Texas Water Development Board

Report 360: Aquifers of the Edwards Plateau

Errata

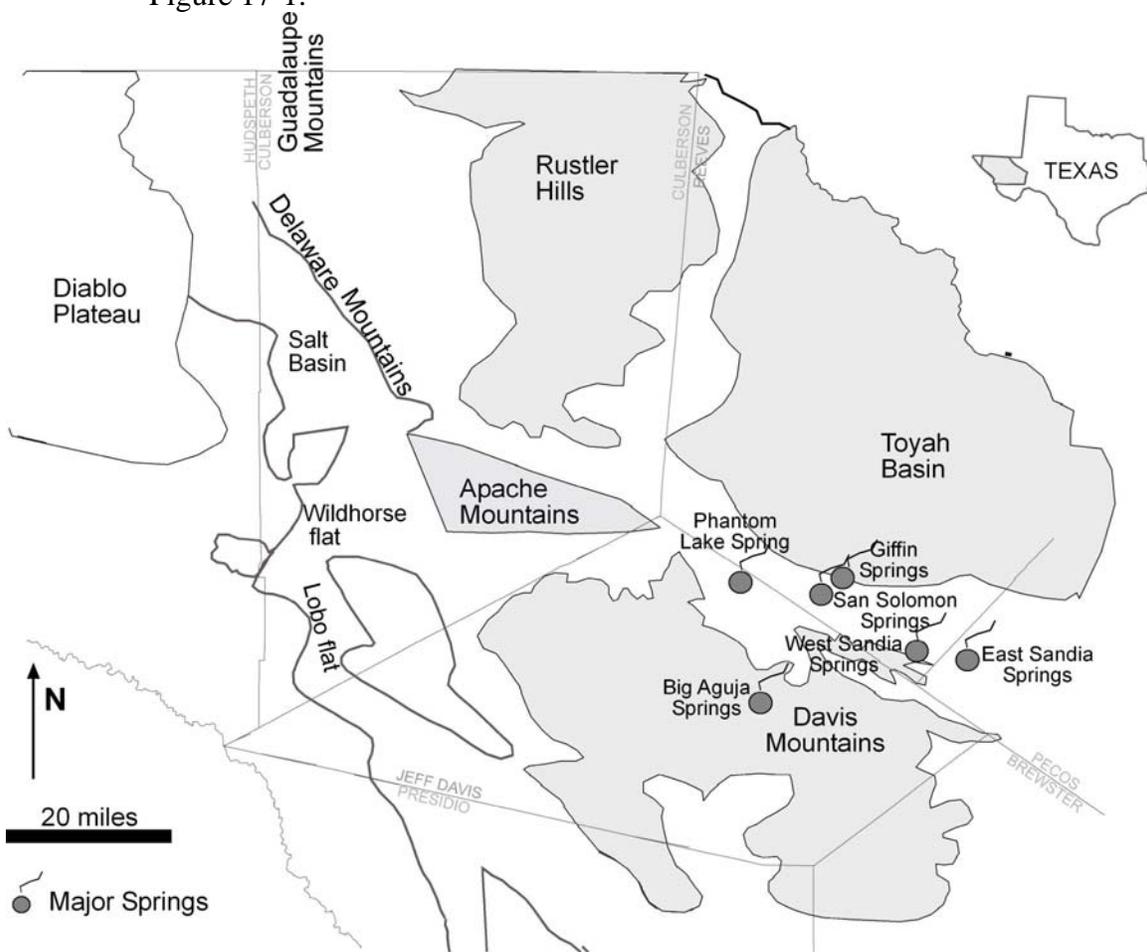
- Page 35, In the second paragraph, the sixth sentence should read "Rates of evaporation are high throughout the plateau and range between 63 inches in the east (Walker, 1979) to 80 inches in the west (Rees and Buckner, 1980)."
- Page 316, The label and location of "Phantom Lake Spring", "Giffin Springs", "West Sandia Springs", and "East Sandia Springs" are corrected in the following replacement of Figure 17-1.

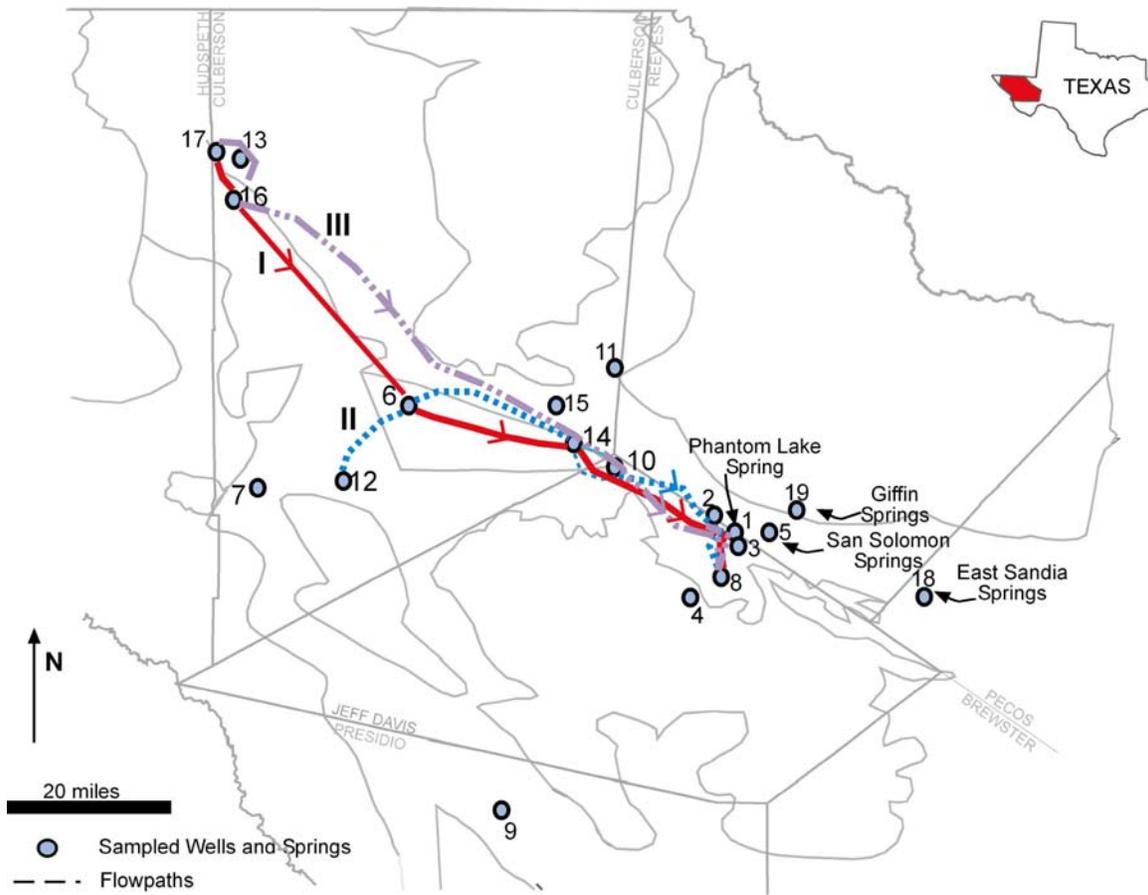
Page 319, The label and location of “Phantom Lake Spring”, “Giffin Springs”, and “East Sandia Springs” are corrected in the following replacement of Figure 17-2.

Figure 18-6: Annual streamflow as measured on (a) the Nueces River at Laguna and (b) West Nueces River near Brackettville and as (c) estimated at the West Nueces River at the confluence with the Nueces River (source data from USGS).

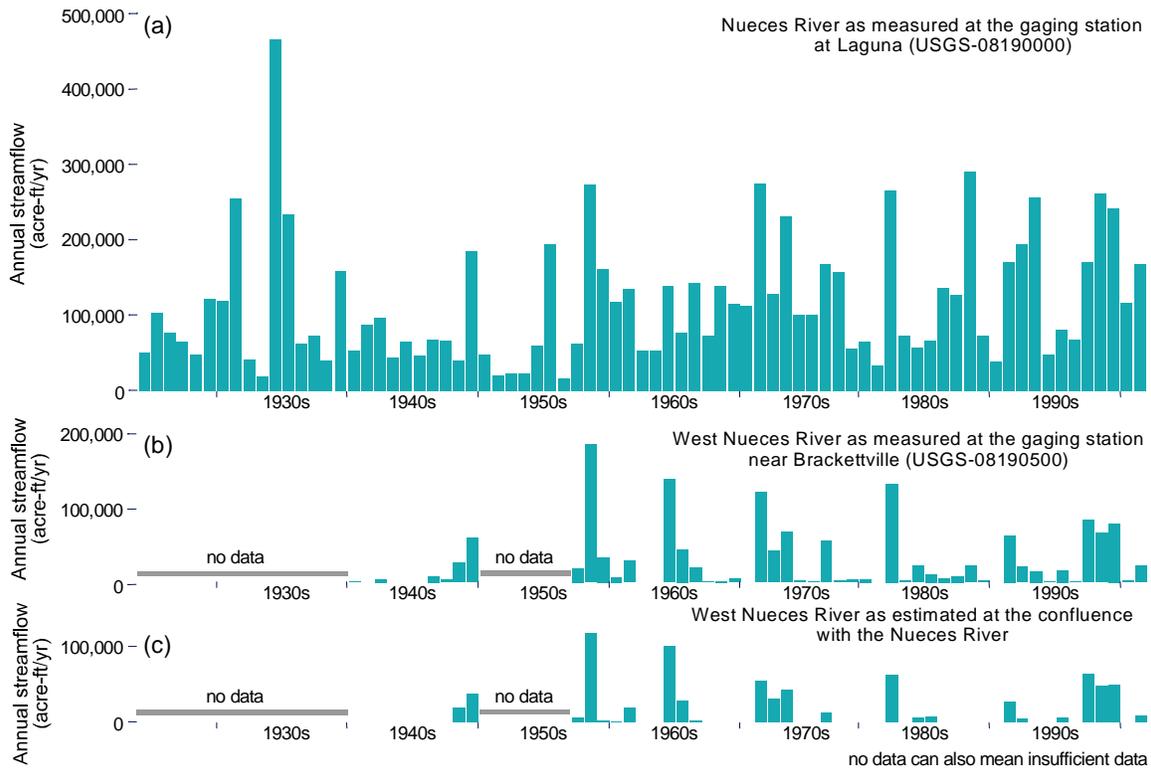
Page 355, In the first paragraph, the figure reference in the first sentence should read “(Figure 18-6)”. Following the first paragraph, Figure 18-6 should be inserted (see below).
